Sydney Metro Project Submission in respect to the Environmental Impact Statement

Prepared for Monte Sant' Angelo Mercy College

June 2016

Appendix A Acoustic Report Peer Review by Wilkinson Murray

FIGURE 4 – PROPOSED CONSTRUCTION WORK AT 194 MILLER STREET (“NORTHERN SITE”) SOURCE: EXTRACT FROM EIS

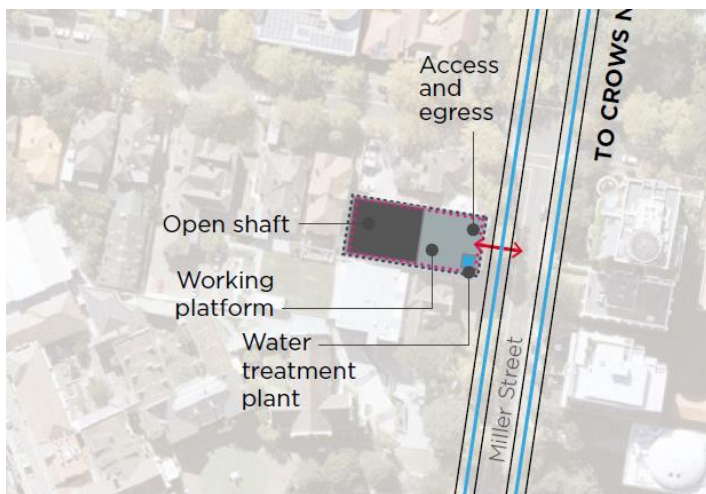
There is no construction detail or methodology outlined in the EIS. The process is only graphically described in what might be described as "info graphics" that depict the concept but without detail of matters such as:

- Location of piling.
- Excavation setbacks from boundaries.
- Design, height and setbacks of the proposed acoustic shed.
- Truck access design to Miller Street.

FIGURE 7 – CROSS SECTION OF VICTORIA CROSS STATION INCLUDING PROPOSED SERVICES BUILDING (SOURCE: EIS)

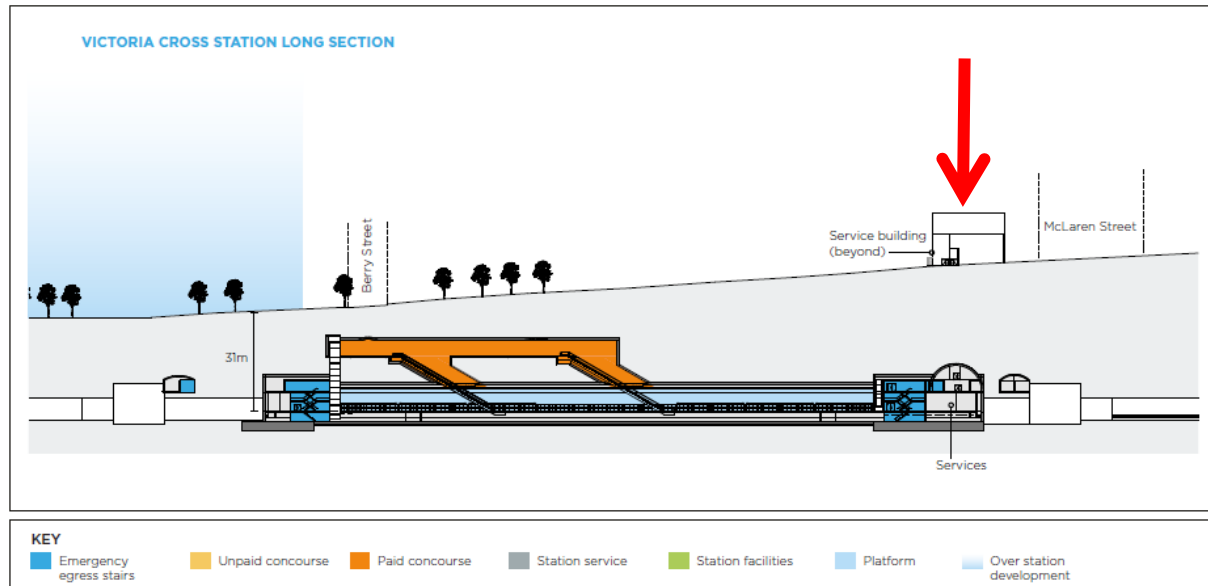
- A services building (with no design detail) to be constructed on site.
- It is indicated that this building could be 10-12 metres high and setback in line with adjacent buildings, but there are no plans that support this proposition other than the cross section illustrated in Figure 7 below.
- The services building is described as being of utilitarian character as a service building noting that it sits within a heritage context, but there is no detail.
- A service building will provide for tunnel ventilation and smoke exhaust in the event of an incident

While a broad visual impact assessment has been undertaken of the precinct as part of the EIS, there is no design detail of the proposed services building to be located on the northern site. It is therefore impossible to assess the likely impact of the future development when no design detail or indeed key principles are articulated. The need for such detail is heightened given the location of this site amongst heritage listed buildings.

We submit that there is insufficient design detail to satisfy the SEAR's and to have any certainty regarding the design quality and visual impact of the future development.

FIGURE 8 – PLAN SHOWING RELATIONSHIP BETWEEN THE ARTS AND CULTURAL COMMON AND PROPOSED TUNNEL SHAFT

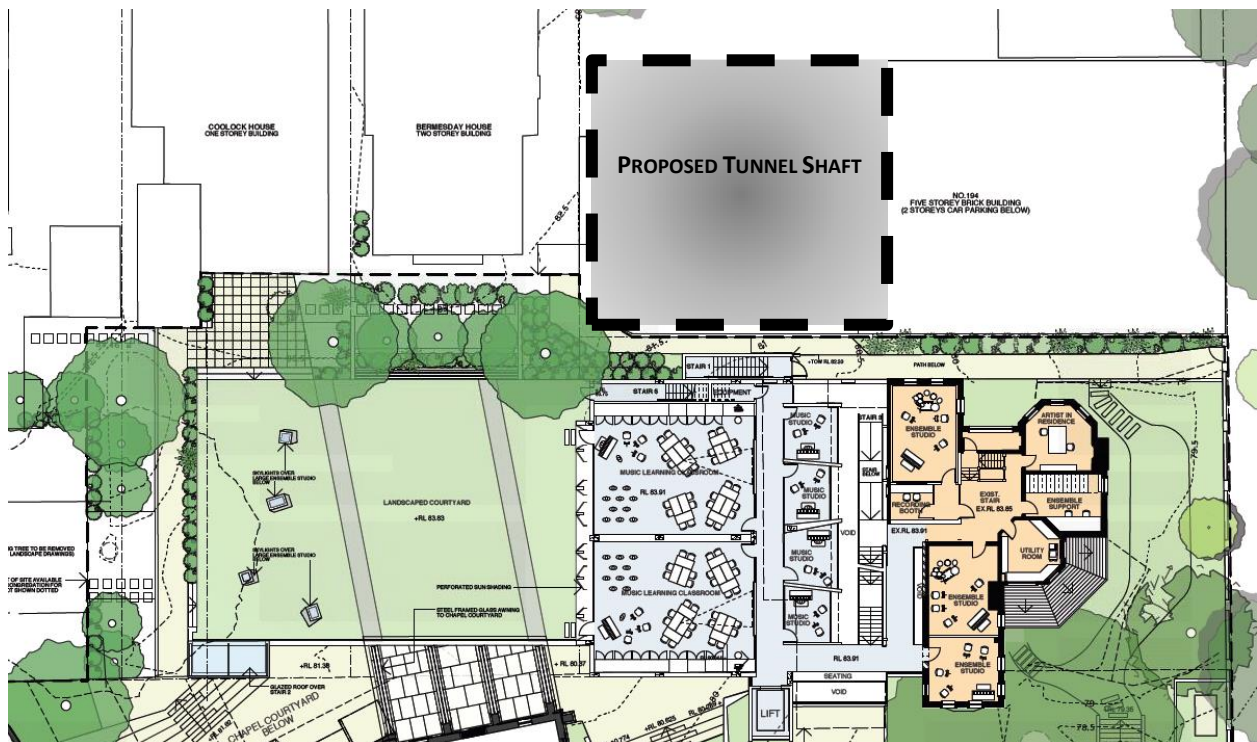
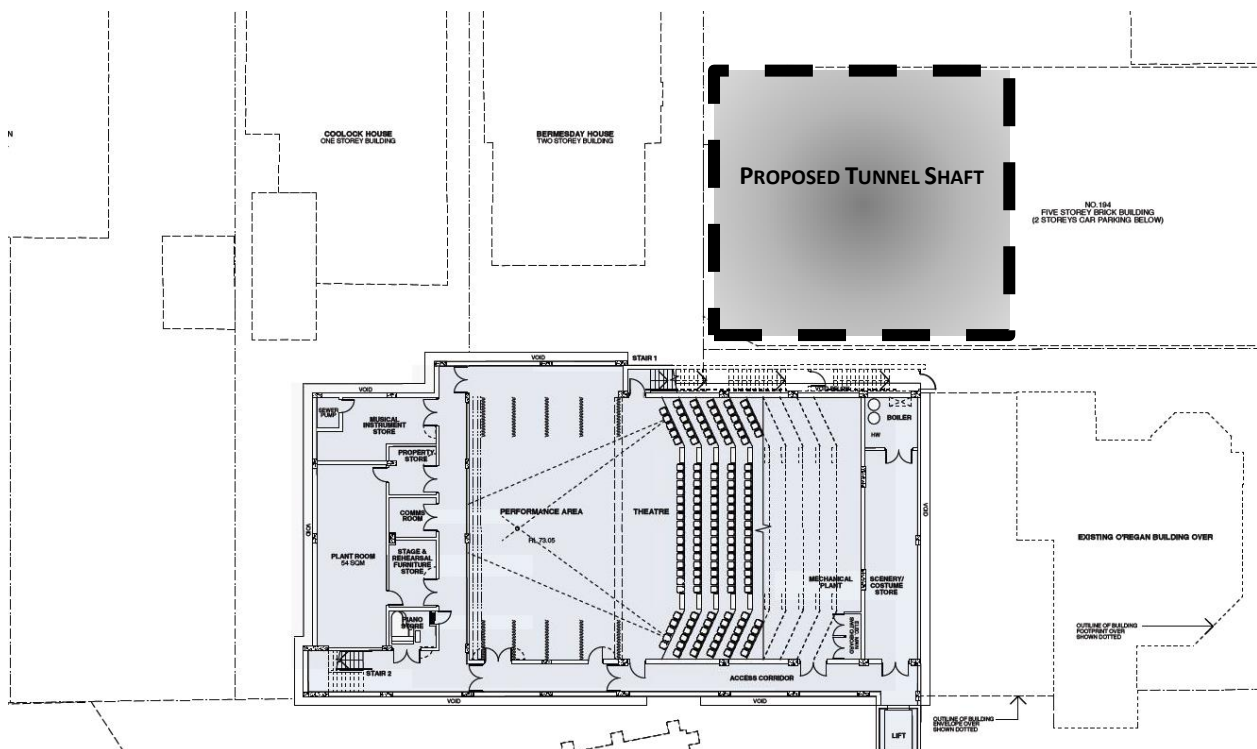
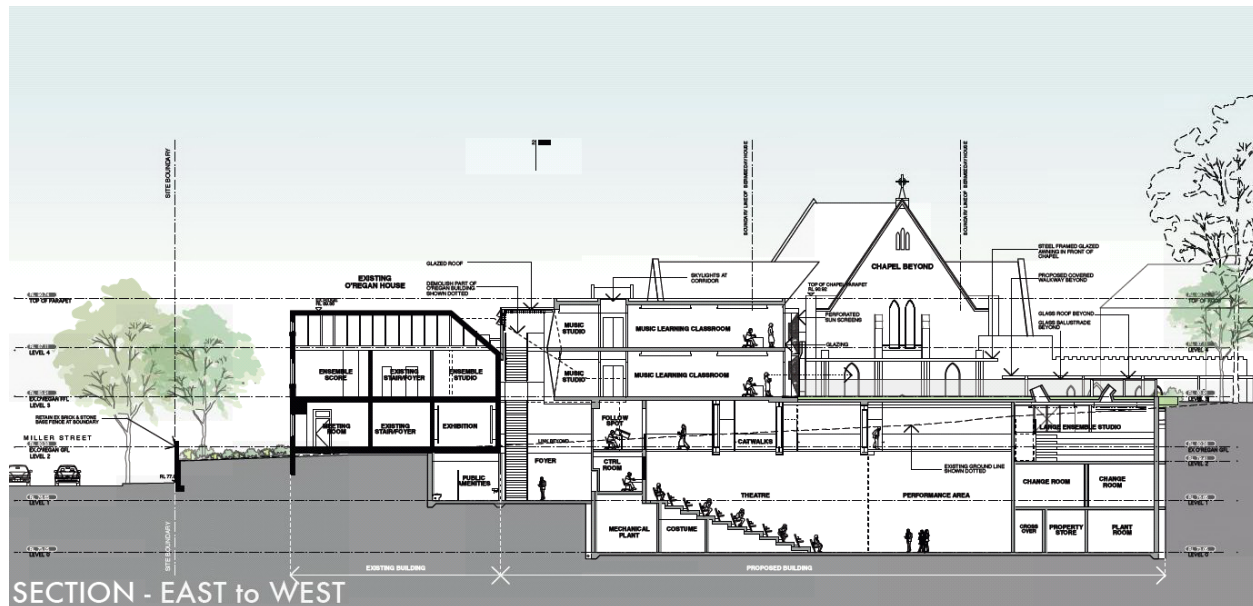
These plans illustrate how close the proposed tunnel is to the existing arts and cultural common and the significant potential for impact.

Airborne noise from construction works is predicted to be greater than 75 dBA at the Arts and Creativity Common. These noise levels will limit effective communication in areas in the northern outdoor areas of the school and outdoor areas rendering these areas unusable.

The greatest impacts are on the school is from ground borne noise associated with rock breakers and blasting. Noise from ground borne noise (due to rock breakers) is predicted to be up to 75 dBA in the Arts and Creativity Common, Theatre and adjacent residences. In the case of the Theatre, which is below ground level, this will be the dominant noise source from construction.

The impacts on the education components, particularly the entire Arts and Creativity Common, around the northern shaft will be significant and will render these areas not fit for use.

Therefore it is considered that the location of the northern shaft should be reconsidered and relocated away from the school site. In addition alternative excavation techniques, such as rock sawing should also be considered as a reasonable and feasible method of excavation. (our emphasis).

FIGURE 12 – PROJECTED TRUCK MOVEMENTS (SOURCE: EIS)

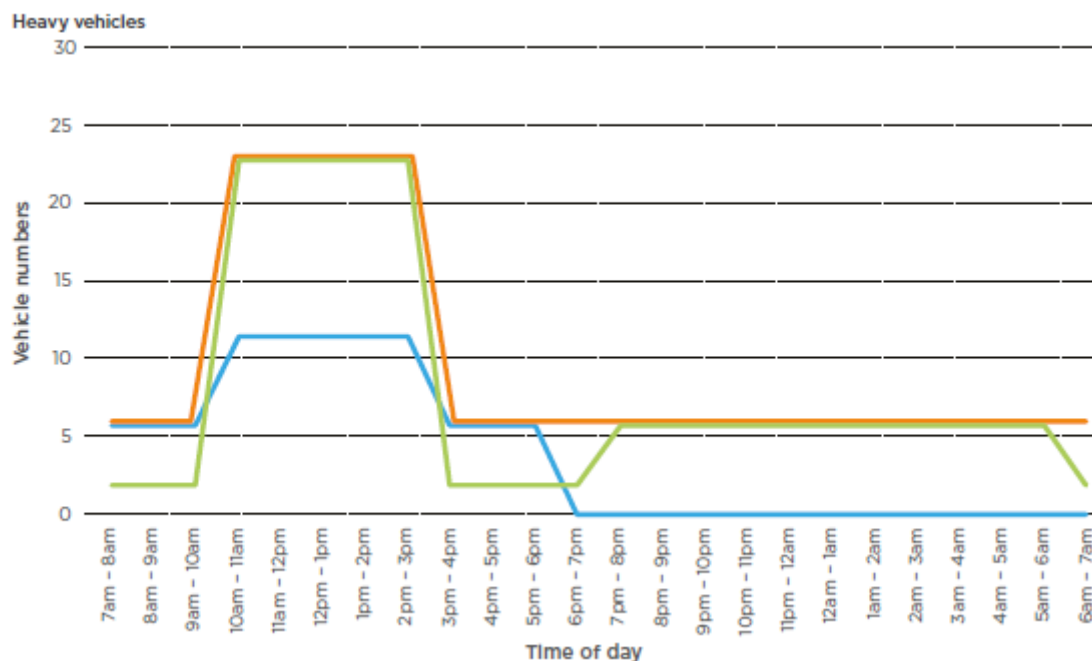
This graph shows that the peak heavy vehicle movements in the AM peak period (7am to 10am) would be six heavy vehicles per hour during the demolition and excavation phases.

What is not however clearly explained in the EIS is the projected heavy vehicle movements of approximately 23 per hour between the times of 9am to 4pm.

While undoubtedly the concentration of trucks during these hours is designed to avoid the traditional peak hour periods (7am-9am and 5pm-7pm), this approach ignores the significant early peak generated by the school. This school peak occurs from around 3pm Monday to Friday.

Figure 2-2 Aerial of Monte Sant Angelo and Proposed Sydney Metro Construction Sites

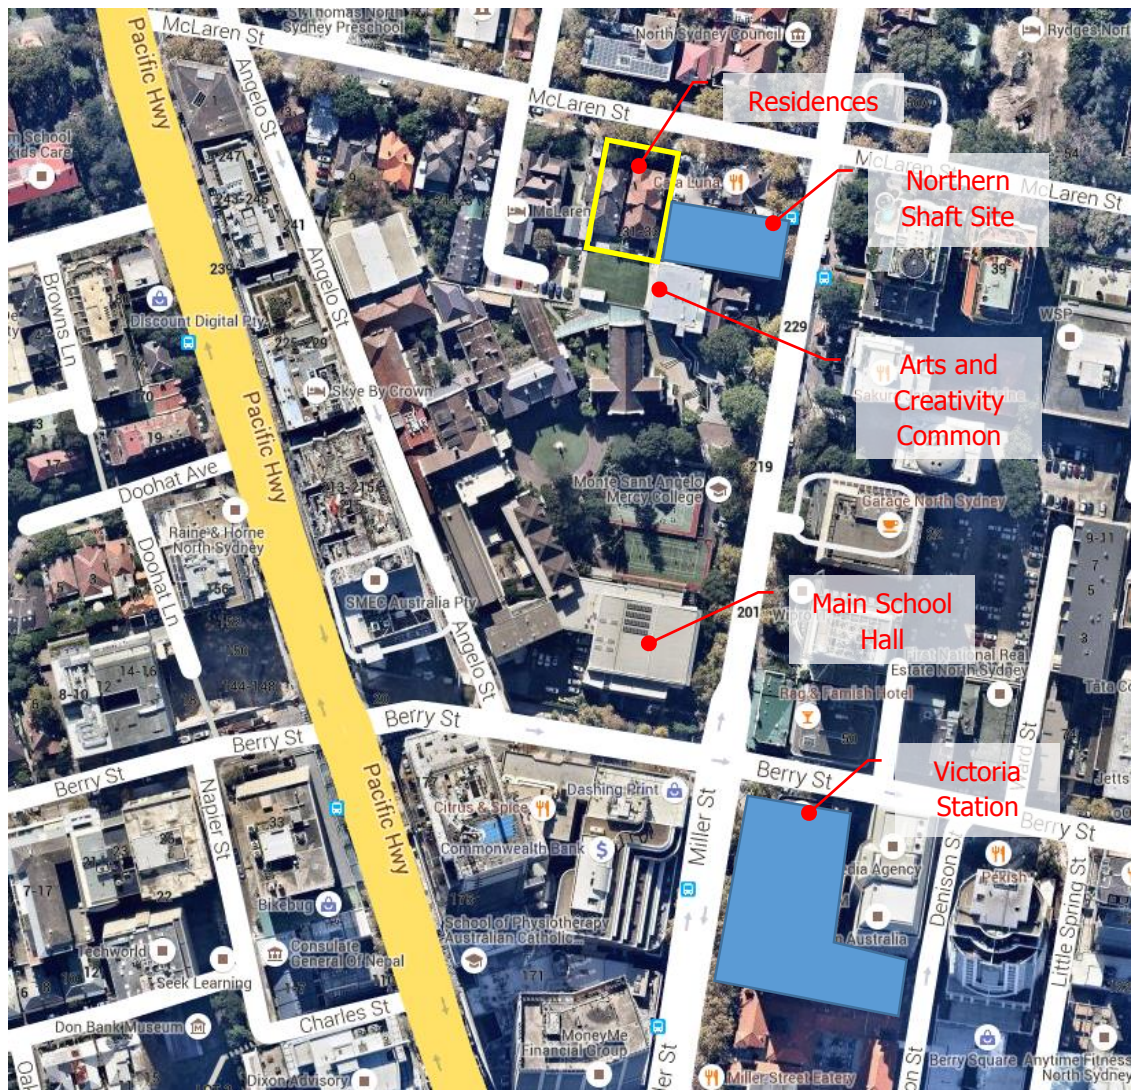
The close proximity of the **Arts and Creativity Common and residences** to the northern shaft is not reflected in **Table 34** of the technical report.
